REQUEST FOR INFORMATION	DATE: January 20, 2017	NO.: RFI-421
--------------------------------	-------------------------------	---------------------

Project Name: 15051-Webster University Interdisciplinary Science Building	Project No.: 15051
---	--------------------

Subject: Caulk joints at south vestibule

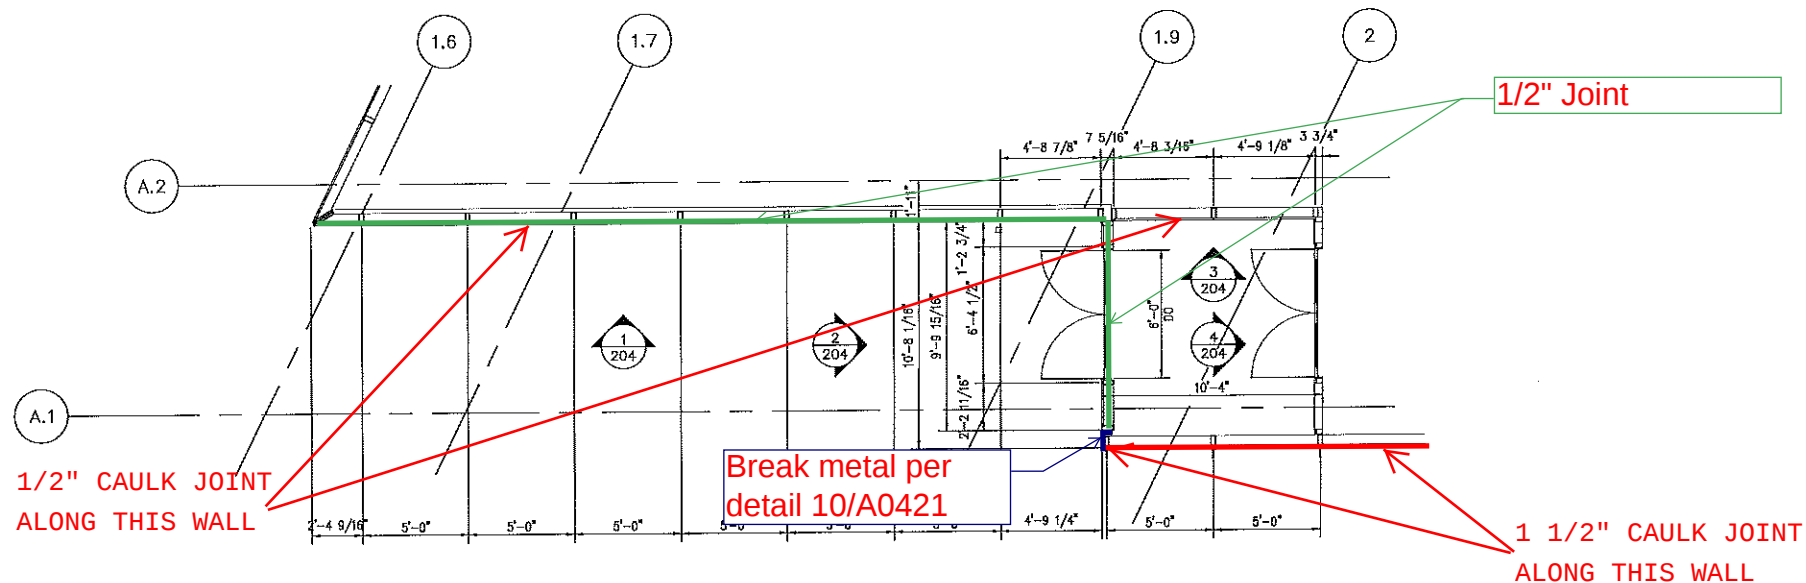
See attached sketch. The South vestibule at the 2nd level has 1/2" caulk joints on the North (interior) wall and 1 1/2" on the South (exterior) wall. These sills need to be at the same elevations for proper installation.

Suggestion: Please advise. The joint size can be adjusted per the curtainwall contractor but needs to be the same.

WE HAVE A 1/2"
JOINT HERE

WE HAVE A 1 1/2"
JOINT HERE.

THE SILLS WILL NOT LINE UP FROM ONE WALL TO THE OTHER. WE NEED TO KNOW HOW TO PROCEED

Maintain the 1/2" caulk joint on both sides of the door. Break metal will separate the 1/2" and 1 1/2" joint size. See detail 10/A0421 (see below)

1/2" CAULK JOINT
ALONG THIS WALL

Break metal per
detail 10/A0421

1 1/2" CAULK JOINT
ALONG THIS WALL
